# TECHNICAL SERVICE BULLETIN

NO. 73/D/6

Difficult Selection and  
Disengagement of Reverse Gear

Austin Marina

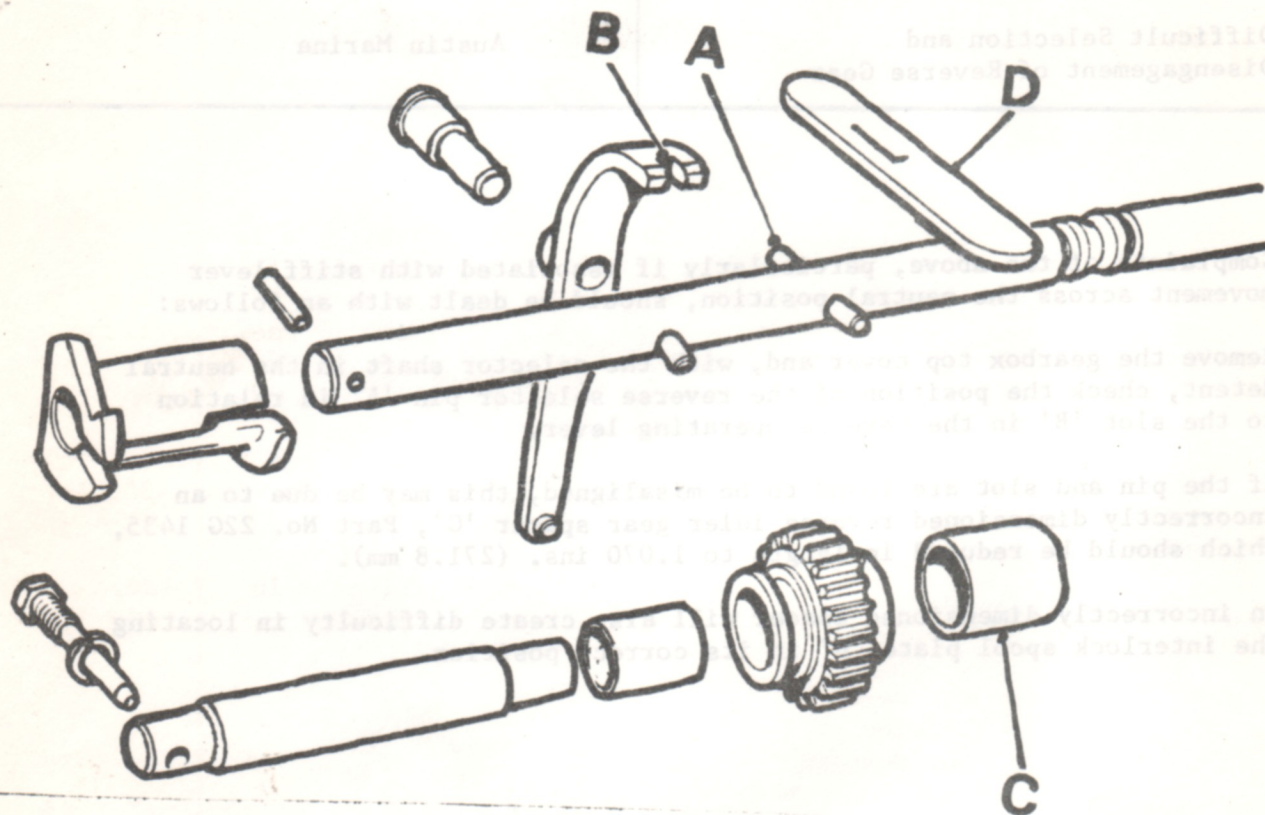
Complaints of the above, particularly if associated with stiff lever movement across the neutral position, should be dealt with as follows:

Remove the gearbox top cover and, with the selector shaft in the neutral detent, check the position of the reverse selector pin 'A' in relation to the slot 'B' in the reverse operating lever.

If the pin and slot are found to be misaligned, this may be due to an incorrectly dimensioned reverse idler gear spacer 'C', Part No. 22G 1435, which should be reduced in length to 1.070 ins. (271.8 mm).

An incorrectly dimensioned spacer will also create difficulty in locating the interlock spool plate 'D' in its correct position.
